SERVICE BULLETIN

APPLICABILITY: 2012-13MY Impreza 2.0L Models
 2013MY XV Crosstrek
 2014-15MY Forester

NUMBER: 12-157-13R

SUBJECT: Rattle or Buzzing Sound from “A” Pillar Trim

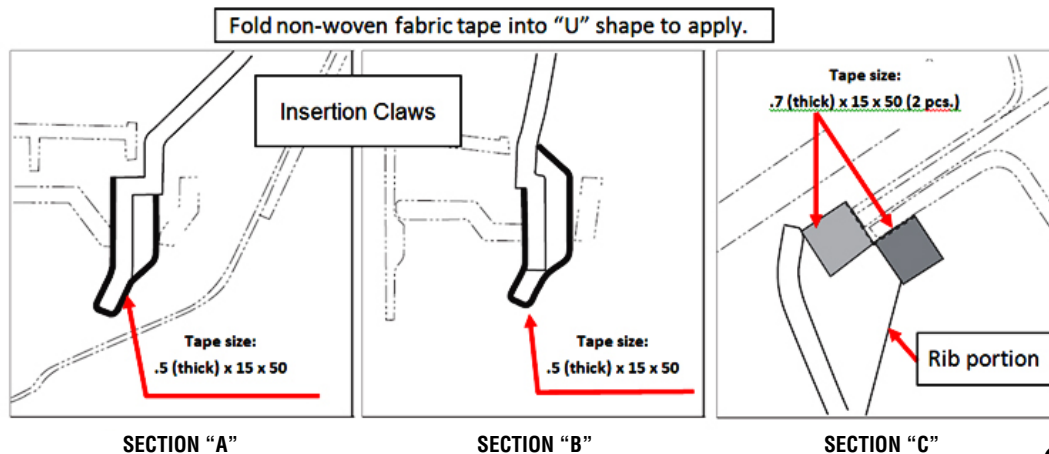
- With the “A” pillar trim at room temperature, clean the 3 areas shown in the illustration below (A, B, and C) with rubbing alcohol applied to a clean shop cloth then allow to dry before installing the non-woven material.

NOTE: Any reference relating to Rib portion “C” is not applicable to Forester models.

- Cut the non-woven material pieces to size then peel the adhesive backing and apply to the insertion claws and rib portion as shown in the illustration below.

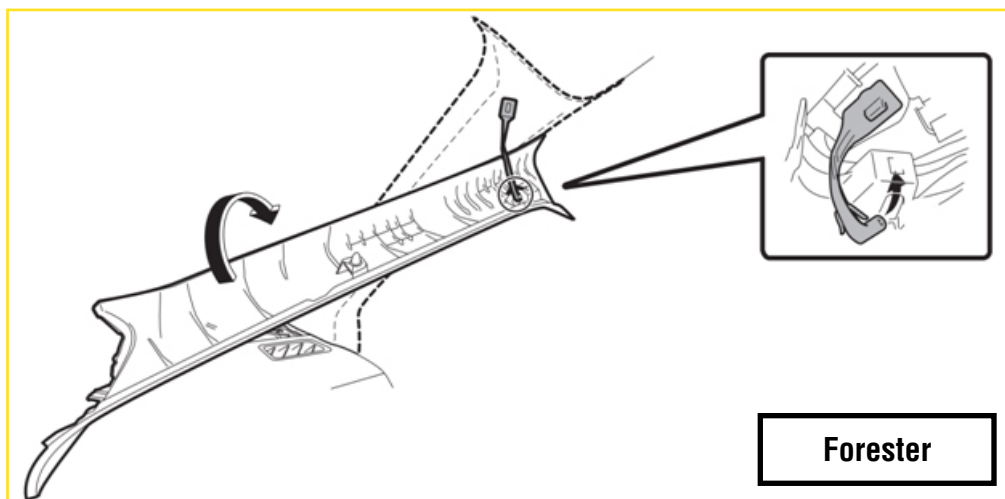
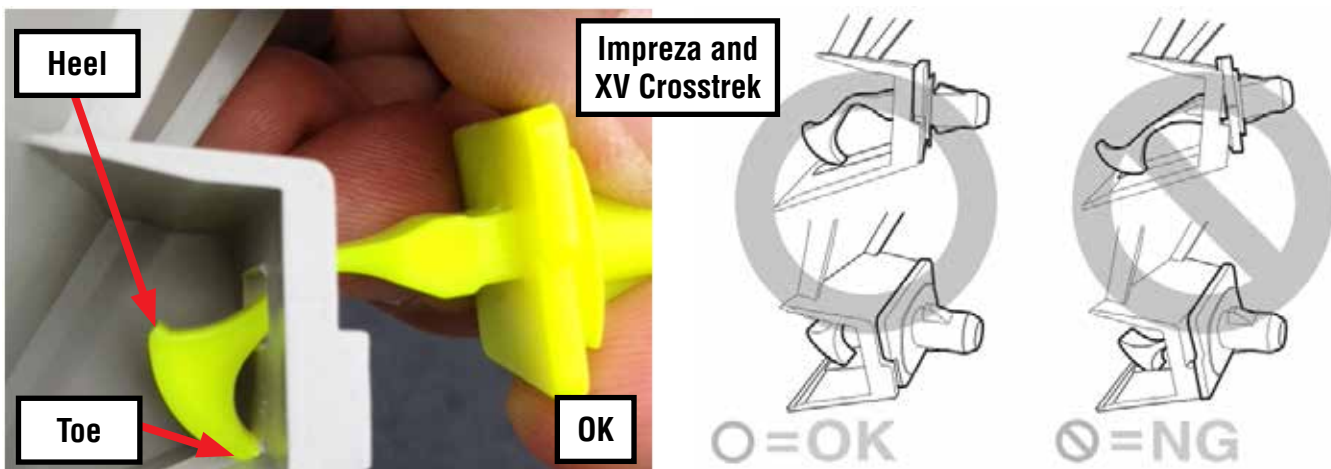
- For section C (excluding Forester), the material must be doubled (2 layers thick) to achieve the required thickness as shown in the photo below.

- Once all the non-woven material pieces are in place, re-install the “A” pillar trim using a **NEW** tether clip.

IMPORTANT: The tether clips are **one-time use items** and **must** be replaced any time they are removed. Additionally, the tether clip must be installed into the “A” pillar trim in the proper direction. See the photo and illustrations below for proper installation details.
